MeshSat field kit V2, Option A(i) lid pack: sheet A1-2 sections: the module under the ceiling over the face, at the worst room

MeshSat field kit V2, Option A(i) lid pack: sheet A1-3 the arrangements that fit, and the owner decision

MeshSat field kit V2, Option A(i) lid pack: sheet A1-4 the hinge harness: route, travel, ties, disconnect; the QMX DC lead re-routed

MeshSat field kit V2, Option A(i) lid pack: sheet A1-5 mass and open-lid stability

MeshSat field kit V2, Option A(i) lid pack: sheet A1-6 the base pockets: section 8's 4S6P at the same worst figures

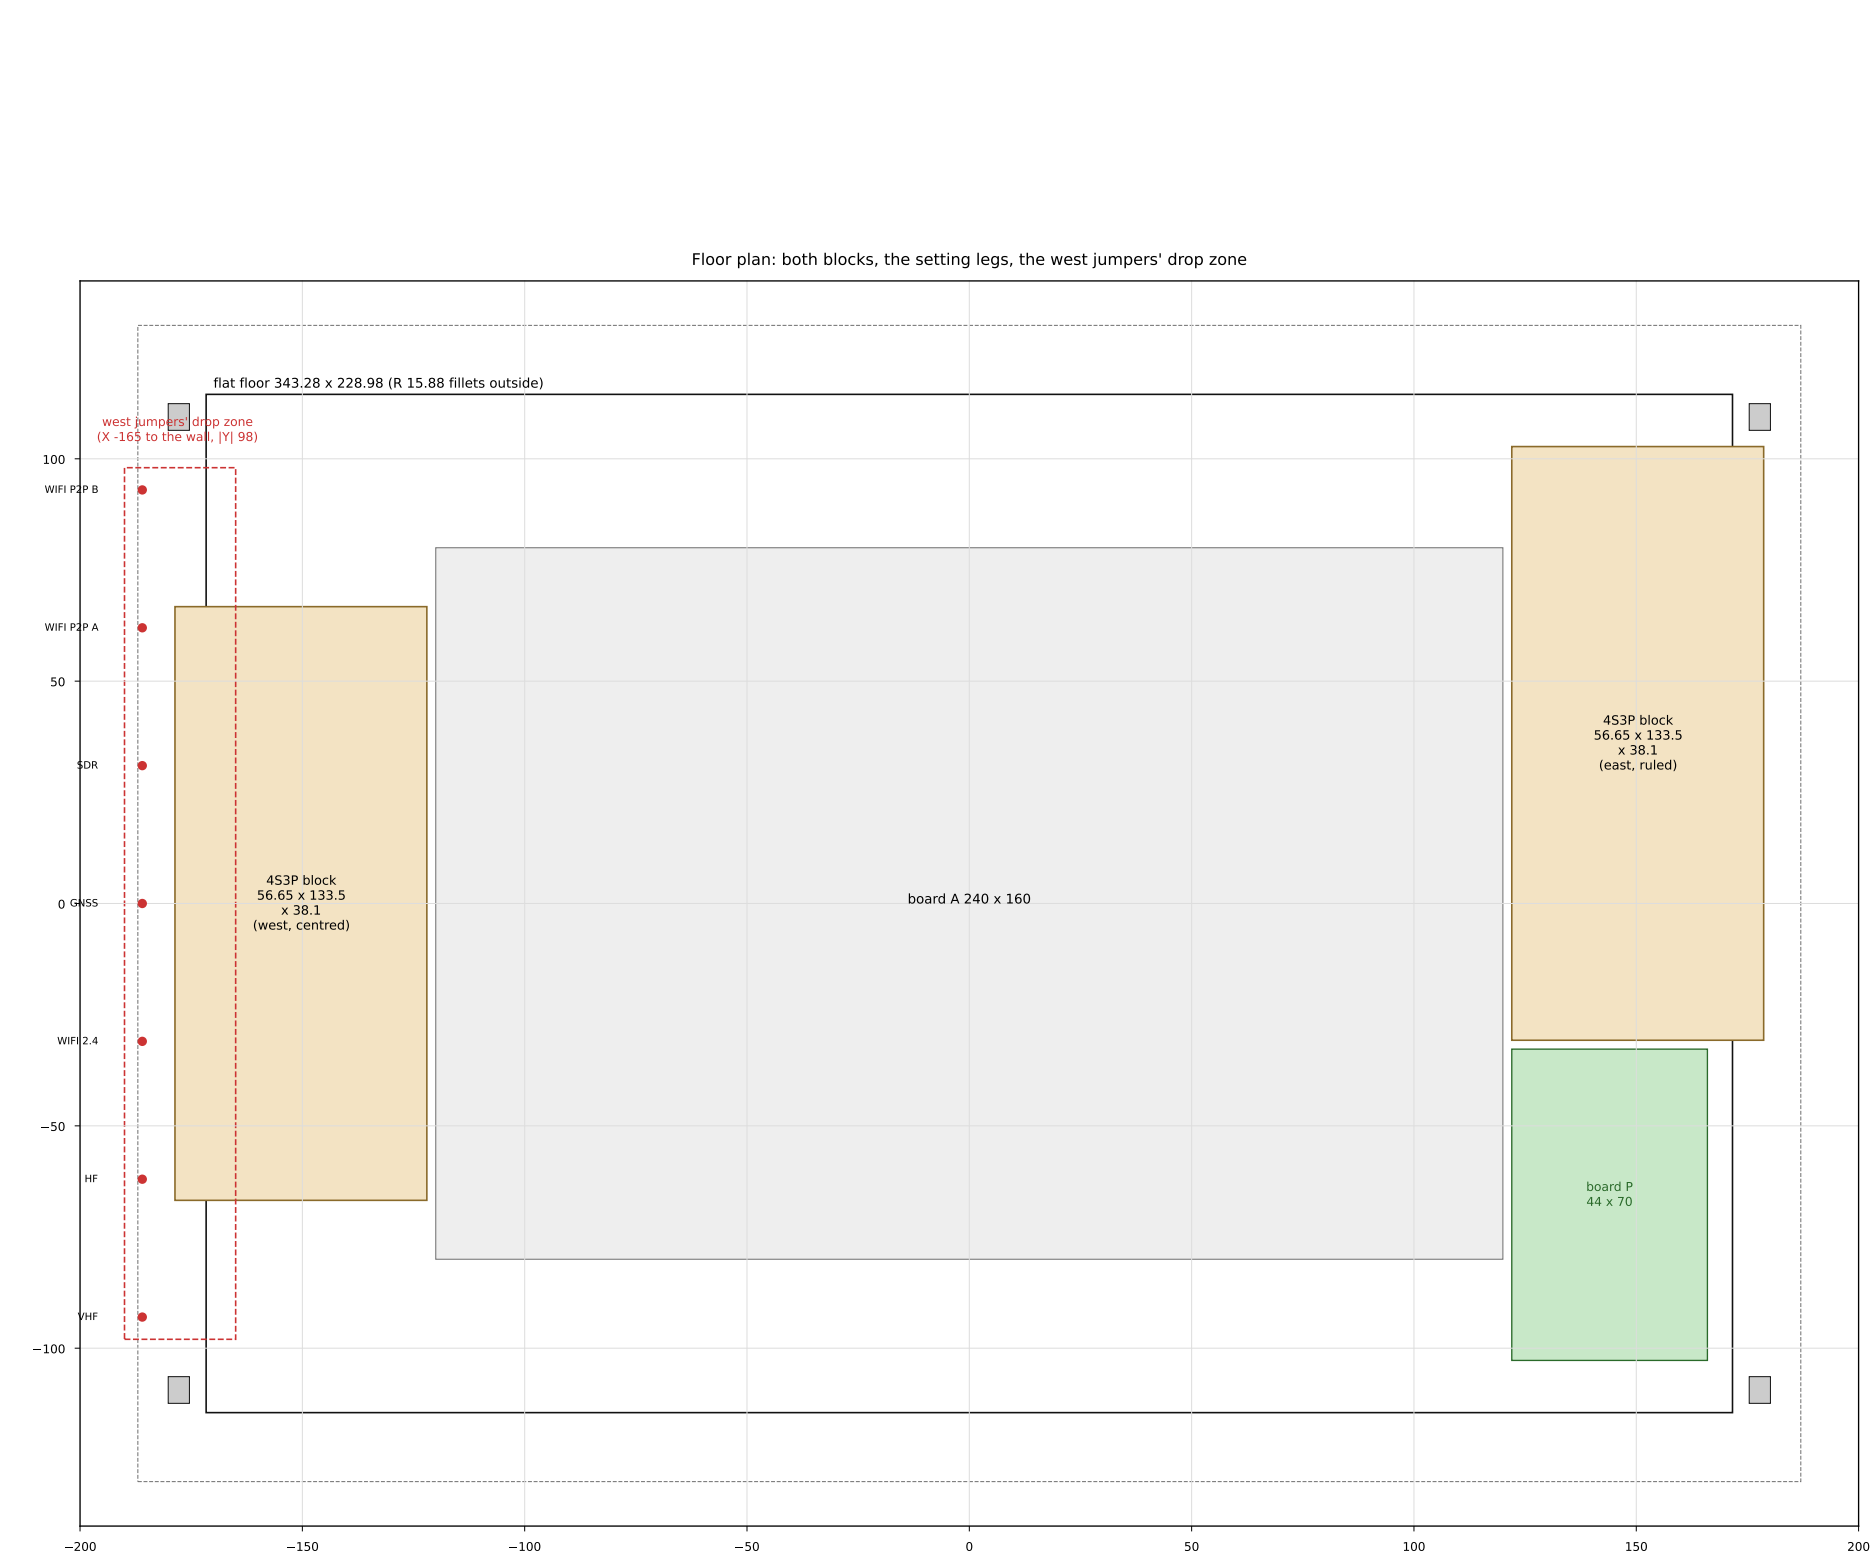
ROW	worst	x2	verdict
M4a	1.85	0.85	OPEN: placed by hand; T4
M4aw	1.85	0.85	OPEN: placed by hand; T4 (mirror: Peli's cavity and
M4b	7.38	6.38	MET
M4bw	7.38	6.38	MET (mirror: Peli's cavity and the RF entry plates a
M4c	3.18	1.80	MET
M4cw	3.18	1.80	MET (mirror: Peli's cavity and the RF entry plates a
M5	1.77	0.27	OPEN: placed by hand, the legs' locator; T4
M5w	37.77	36.89	MET (the block's Y place is not ruled; centred here)
M6	3.66	2.90	MET
M6w	3.99	n/a	OPEN: the x2 reading is not computed by A06's tool;

WEST RF JUMPERS: 5 of 7 west cables (Y -62, -31, 0, 31, 62) fall onto the west block; the slot over it is 7.19 at the worst less C33's zone (3.99); the only drop east of it is its 2.0 gap to board A, under one RG-316 (2.49): FAILS AS ASSUMED, held OPEN (section 8b, the M17 class): the west RF entry is re-planned before the west block is taken. Hold-down S-27 open for both blocks.
